Comments on Potential Geologic and Seismic Hazards Affecting Proposed Liquefied Natural Gas Site in Santa Monica Bay, California

Open-File Report 2008-1344

Twenty-seven reviewers, all authors of this report, commented on different sections of the document written by Fugro West, Inc., titled “Exhibit B Topic Report 6—Geological Resources.” Below are their comments, edited only to increase clarity and decrease redundancy. They are arranged here in section order of the Geological Resources document. When multiple reviewers comment on the same section, their comments are labeled as Reviewer 1, Reviewer 2, etc. These labels only apply to that particular section; Reviewer 1 in one section is usually not the same as Reviewer 1 in another section. Reviewers are not individually identified.

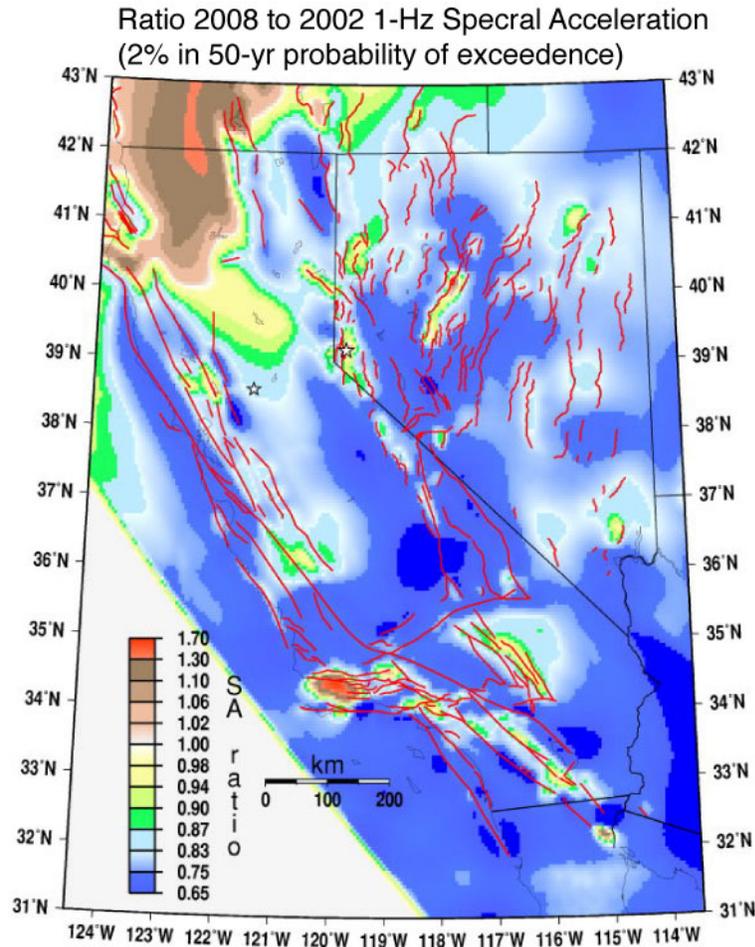
Significant updates to the earthquake hazard assessment in California have been published during 2008, including a new version of the USGS National Seismic Hazard Mapping Project (NSHMP, 2008) maps and a new earthquake probability forecast known as the Uniform California Earthquake Rupture Forecast version 2 (UCERF2) from the Working Group on California Earthquake Probabilities (WGCEP, 2008). The new NSHMP mapping combines the UCERF2 earthquake probabilities with new models of how much shaking is produced by earthquakes. These new shaking models are known as the Next Generation Attenuation (NGA) relations. These changes have some significant effects on hazard assessment including: (1) there is often increased motion on the hanging wall of reverse and normal faults, and (2) intermediate- to long-period median

ground motion estimates are reduced compared to previous models (~25% near some of the major faults such as the San Andreas). Figure 2 highlights some of these effects, expressed as a ratio between the 2008 and 2002 NSHMP estimates.

We recommend that the hazard assessment provided in the Geological Resources document be compared for consistency with the NSHMP 2008 results. Ideally a ratio grid for the regions of interest similar to that of figure 2 would be produced. Further, because the Whittier-Elsinore and San Andreas Faults are discussed in the Geological Resources

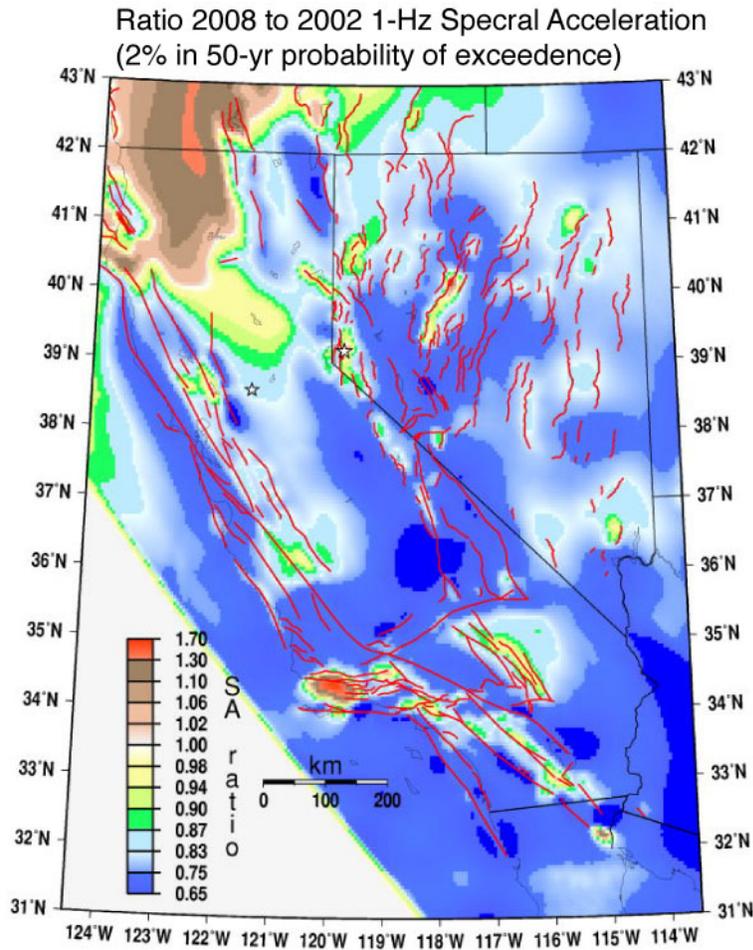
My main comment is that significant updates to the earthquake hazard assessment in California have come on line during 2007-2008, including a new version of the USGS National Seismic Hazard Mapping Project (NSHMP, 2008) maps and a new earthquake probability forecast from the Working Group on California Earthquake Probabilities (WGCEP, 2008). The NSHMP mapping uses the Next Generation Attenuation (NGA) models which have the following updates: (1) the use of VS30 for the site condition, inclusion of a depth of rupture factor, (2) inclusion of hanging wall factors, and (3) inclusion of depth of soil factors. All of the models include non-linear site response effects. Three of the models include the effects of the soil non-linearity on the standard deviation. These changes have some significant effects on hazard assessment including: (1) there is often increased motion, even for 1s spectral acceleration, over the hanging wall of reverse and normal faults, and (2) intermediate to long period median ground motion estimates are reduced compared to previous models (about 25% near some of the major faults such as the San Andreas). The attached figure 2 highlights some of these effects expressed as a ratio between the 2008 and 2002 NSHMP estimates.

A recommendation is that the hazard assessment provided by Fugro West, Inc., be compared for consistency with the NSHMP 2008 results. Ideally a difference grid for the regions of interest similar to that of figure 2 would be produced. Further, since the Whittier-Elsinore, and San Andreas Faults are discussed, the WGCEP (2007) updated time dependent probabilities for those faults should be considered.

Figure 4. Deaggregation for the Santa Monica site using the USGS (Petersen and others, 2008) model.

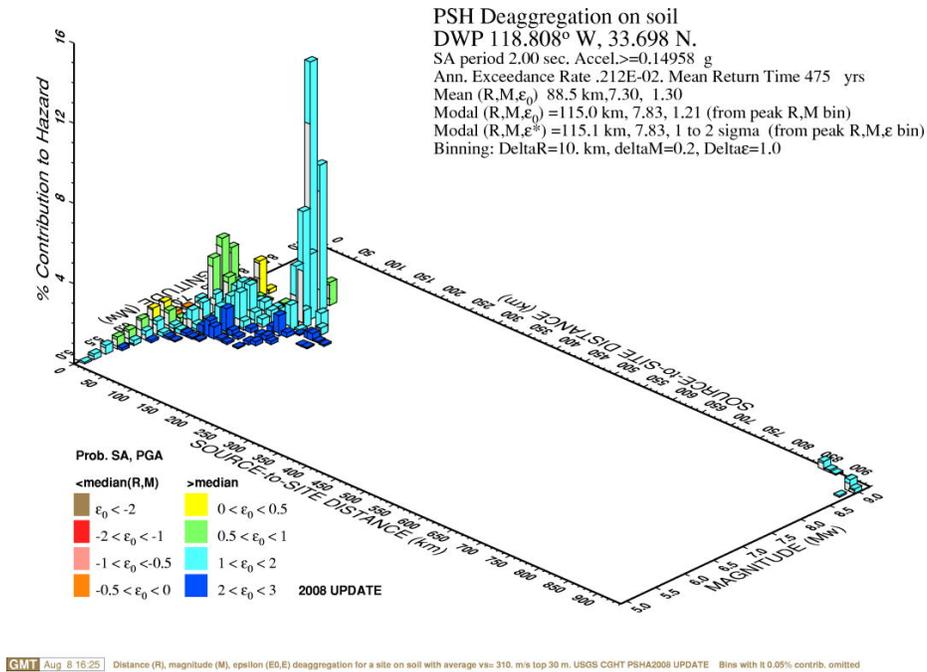
6. Deaggregation plots generated by the USGS contain contributions from the San Andreas Fault whereas the deaggregation plots in the report do not show these contributions from distant sources (see fig. 4).
